KYB: Toyota RAV4 (Front)

KYB shock absorbers 339031/32

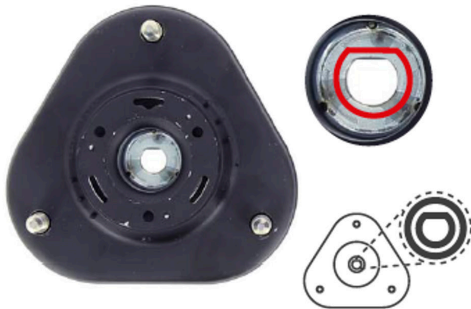
When you replace the strut mount, you must check the shape of the piston rod. KYB shock absorbers 339031/32 have a flat surface and the strut mount must reflect this. These flat surfaces lock the piston rod in the installation position, allowing you to tighten or remove the nut. So, if you use the wrong strut mount, you are not able to assemble the parts correctly.

OE:
48609-0R010 & KYB SM5658
48609-42020
48619-0R010
48619-42010

OE:
48609-12500 & KYB SM5639
48609-12570
48609-42030
48609-42060
